Canada Olympic Park and Adjacent Lands Area Structure Plan Amendment

October, 2020

Trinity Development Group Inc.

Map 7
Parking Allocation

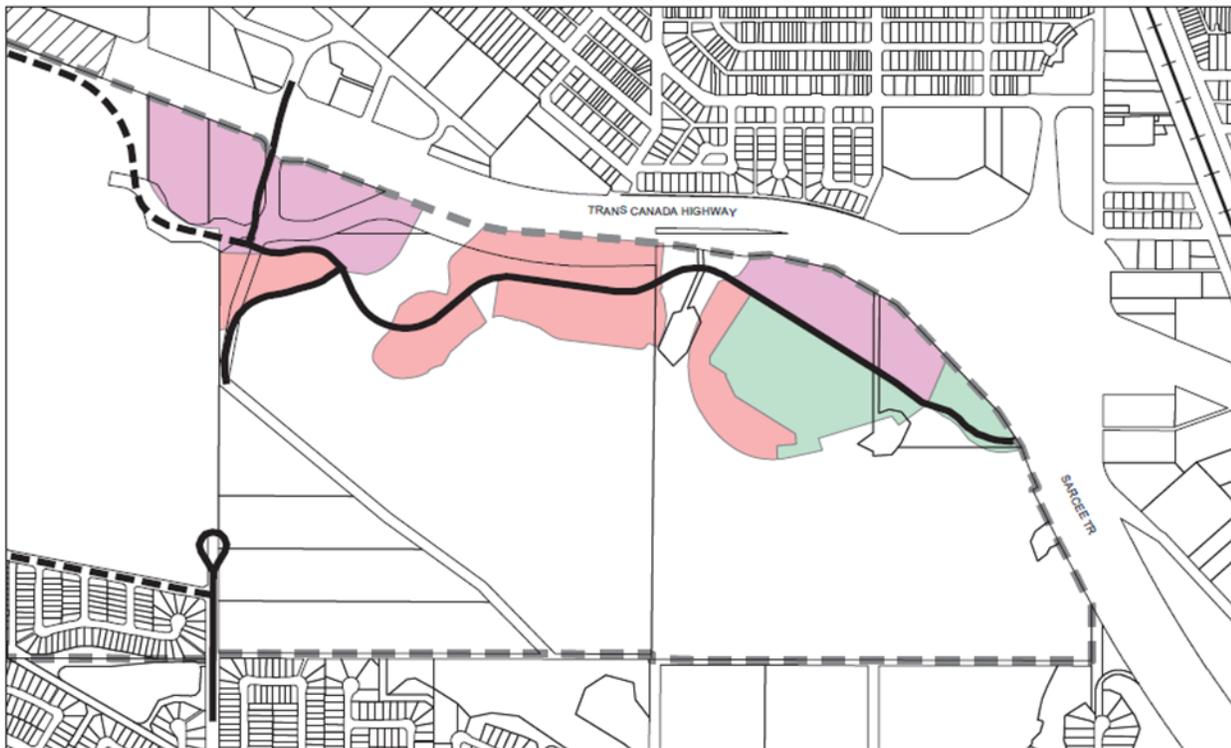
~~(a) The amount of underground and/or structured parking should be provided as per Map 7 Parking Allocation.~~ *The use of structured and underground parking in the Gateway and Commercial Districts is encouraged.*

Rationale: The proposed wording would be less prescriptive regarding how much structured parking is required at each location. Although structured parking provided in Block B (89% provided vs 60% required) and Block I (for Trinity- 55% provided vs 0% required, for Nautical Lands Group – 100% provided vs 0% required) already exceed ASP requirements, future development on some blocks may be of a different use or form than originally envisioned and may not meet individual site expectations even though overall the goal for the development has been met. As the use and form of development has changed from the original concept for which these parking requirements were devised, future applications should be given an opportunity for relaxations if necessary. If development can proceed towards the highest and best use, underground/structured parking will be provided. Since the ASP does not allow for relaxations and no other known ASP specifies a required percentage of structure parking, removal of Parking Allocation Map 7 is requested.

A.5.4 Street Cross-Sections

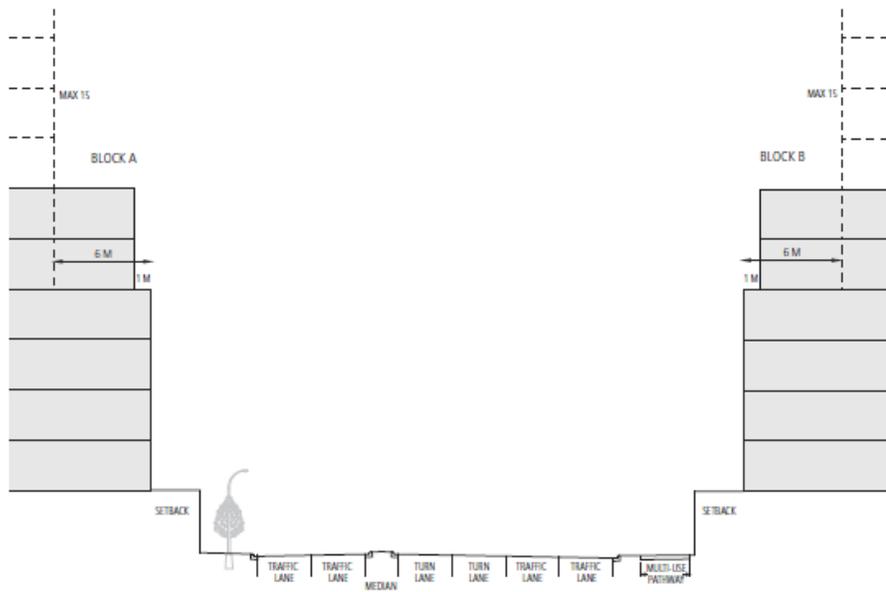
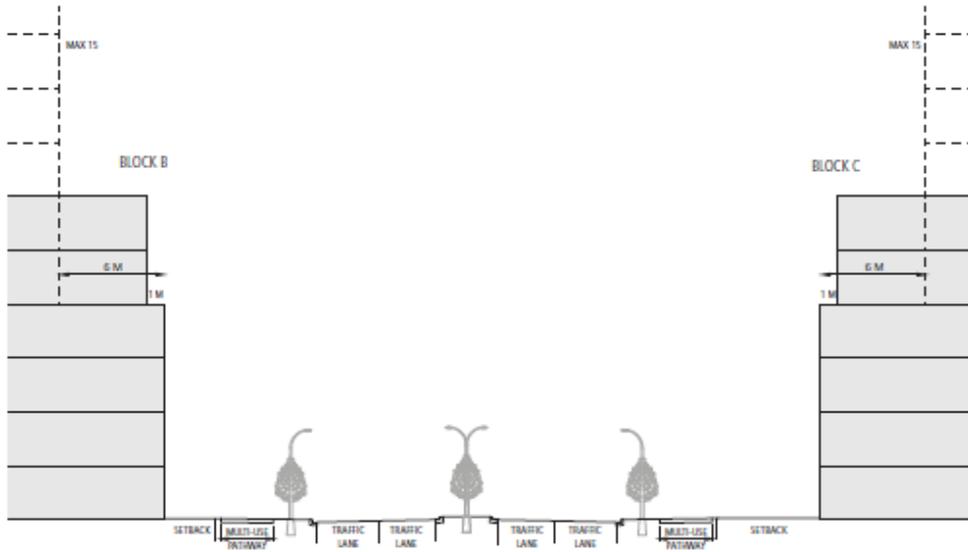
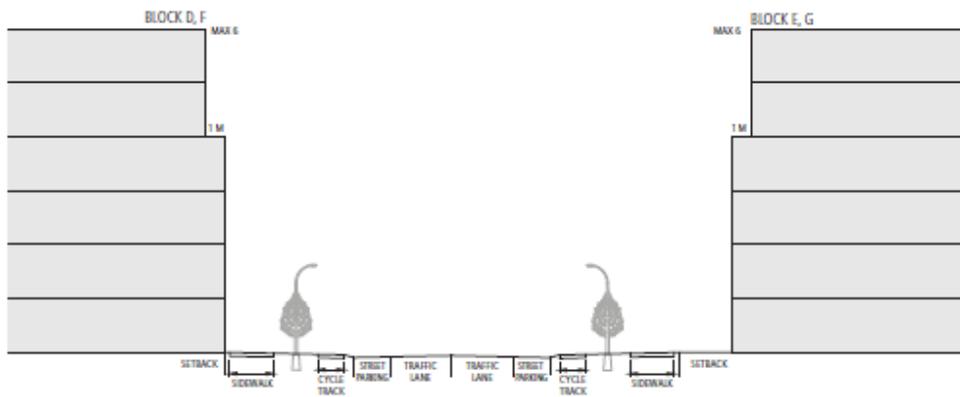
- ~~(a) The street cross-sections shown in the figures below depict the general configuration of streets and adjacent building facades (setbacks and height) in the Gateway, Village and Commercial District.~~
- ~~(b) If an applicant proposes to change the design of a street cross-section(s), an amendment to the figure(s) below will be required.~~

Rationale: Delete the section. Streets cross-sections are no longer relevant as all public streets are built. The criteria could be misinterpreted as requirements for private roads which is unnecessary.
